SERVICE BULLETIN

ENGINE - LP TURBINE ROTOR AND STATOR ASSEMBLY - INCORPORATE SERIAL NUMBER, PART NUMBER
AND ATA REFERENCE ON LP TURBINE CASE - CATEGORY CODE 5 - MOD.ENG-72-0073

V2500-ENG-72-0073

LP Turbine Module
Fig.1

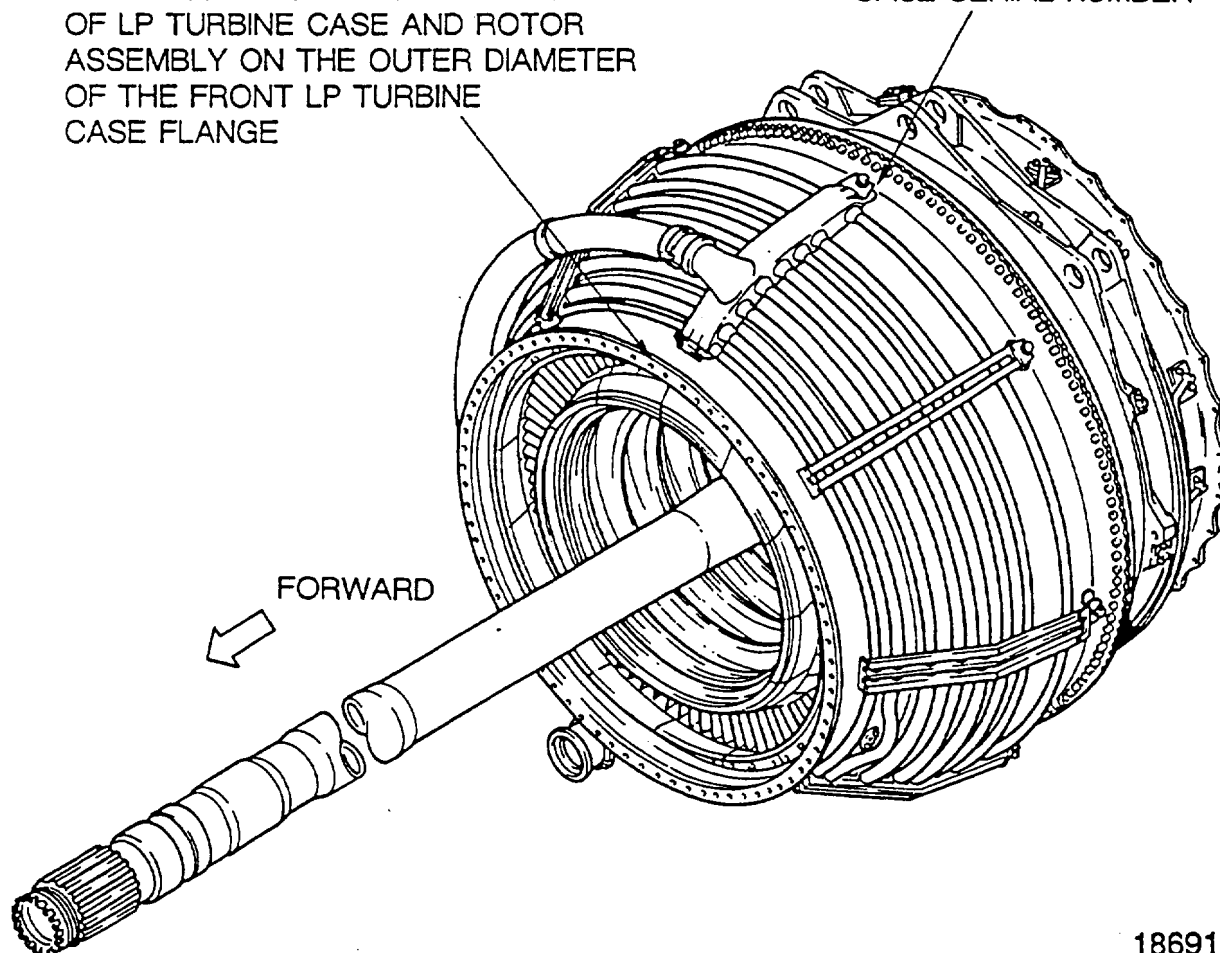
A. Identify the S/N of the LP Turbine Case. Refer to Fig.1.

NOTE: 1. The S/N of the LP turbine Case is located on the rear end, in Top position.

2. The S/N of the LP Turbine Case and Rotor will be the same as the S/N of the LP Turbine Case.

B. Vibropeen the S/N of the LP Turbine Case and rotor assembly on the front LP Turbine case flange in Top position. Refer to Fig.1 and to V2500 Standard Practices/Processes Manual (SPM) TASK 70-09-00.

C. Vibropeen the Part Number 3A1032 of the LP turbine Case and Rotor to the LP Turbine Case, adjacent to the S/N. Refer to SPM TASK 70-09-00.

D. Vibropeen the ATA reference 72-50-10 of the LP turbine Case and Rotor adjacent to the S/N and P/N. Refer to SPM TASK 70-09-00.

VIBROPEEN SERIAL NUMBER,
P/N 3A1032 AND ATA REF. 72-50-10
OF LP TURBINE CASE AND ROTOR
ASSEMBLY ON THE OUTER DIAMETER
OF THE FRONT LP TURBINE
CASE FLANGE

LOCATION OF LP TURBINE
CASE SERIAL NUMBER
